# Update on 802.1 Maintenance Request 193

Rodney Cummings  
National Instruments

# 802.1 Maintenance Request 193

Insert a new Figure 12-6, titled "Points in time for scheduled traffic":

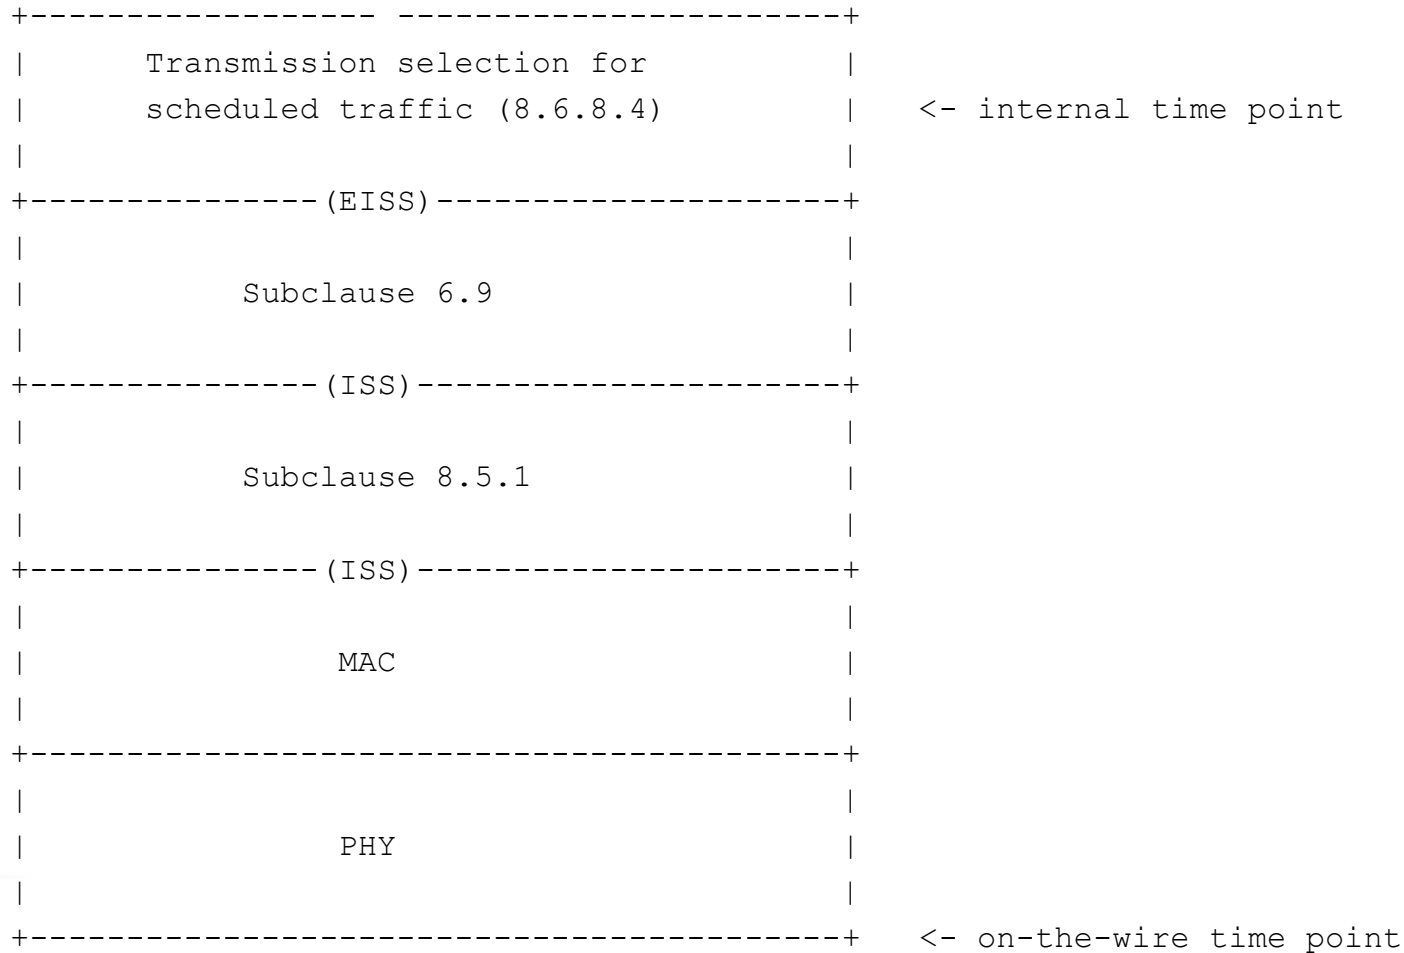
Figure 12-6 shows two points in time for scheduled traffic. The time of gate open/close described in subclause 8.6.8.4 is used for transmission selection, and that point in time exists internal to the Bridge (i.e. above MAC and PHY). A delay exists between this internal time point and the time of transmit on-the-wire. For example, if transition of a gate from closed to open immediately results in selection of a frame for transmission, there will be a delay from that internal time of transmission selection to the start of the frame on-the-wire. The internal time point will have variance (min/max), and the delay to the on-the-wire time point will also have variance.
